Pixel Luminosity Ring IDR report

→ Refresh for Kickoff meeting 31.10.2024

from L.Rossi IDR's [report](#) 20.05.2021 – Here a summary

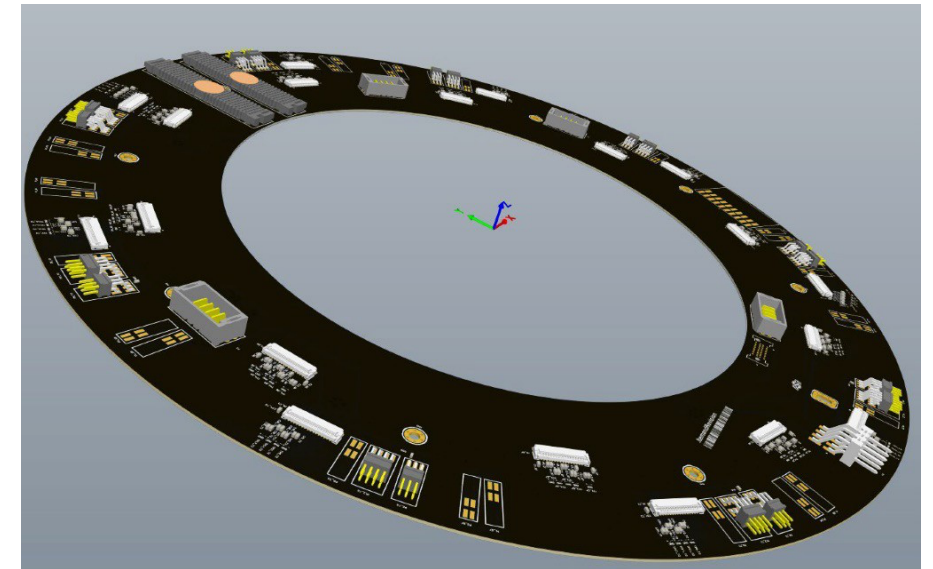
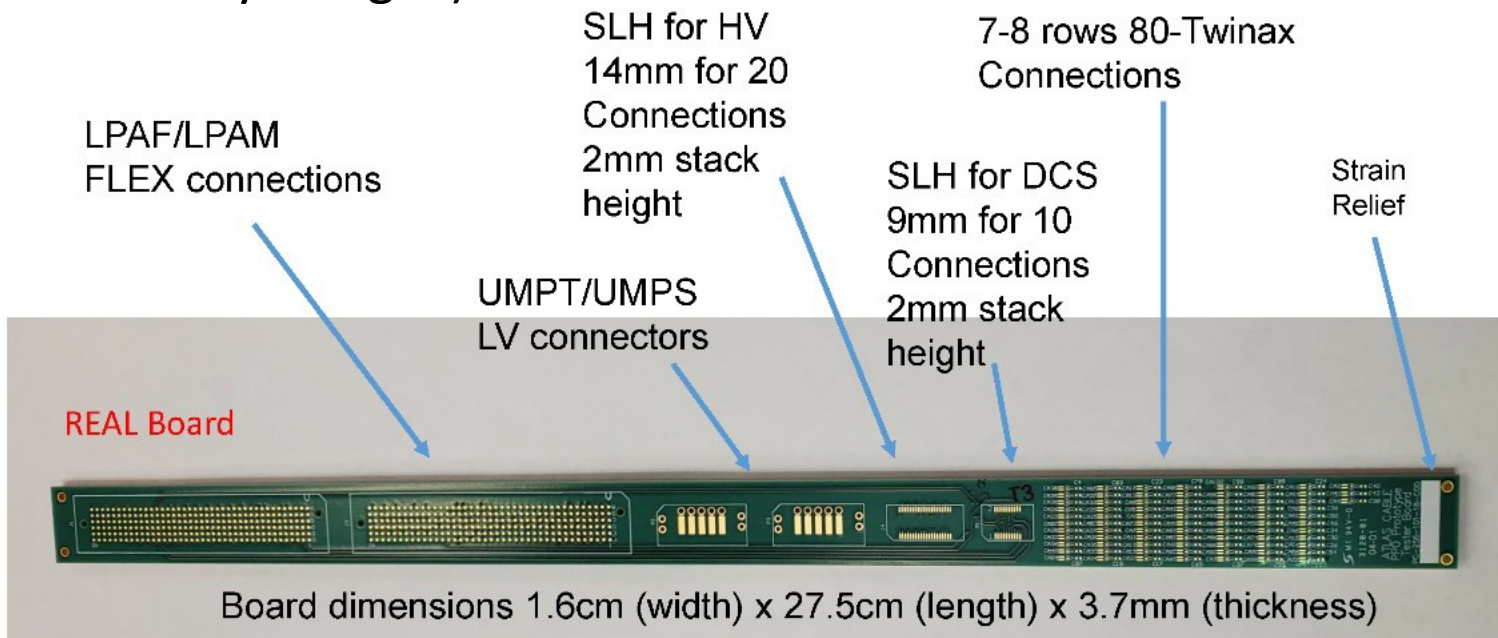
4) The **mechanical stability requirements** are probably easy to be satisfied. They are nevertheless missing and need to be defined (**A2**) (together with the indication of their effect on the luminosity measurement, if any). The same is true for the alignment requirements, which also need to be defined (**A2**).

a) It has been proposed that the PLR participates in relevant reviews for the ITk Pixel tracker where possible. The next such key review would be the Local Supports FDR, which is supposed to happen in Oct 21. We will investigate whether on this timescale the necessary material for a combined Spec Review and PDR could be prepared for the PLR. One challenge will be that the project will not yet be formally approved by ATLAS on this timescale, and hence we will not be able to significantly engage engineering and technician person-power for such reviews. This will be explored within the relevant institutes. It might be necessary to further delay the PLR review, but this carries the risk that inconsistencies could be frozen into the PLR designs if they are not reviewed together with the ITk Pixel designs.
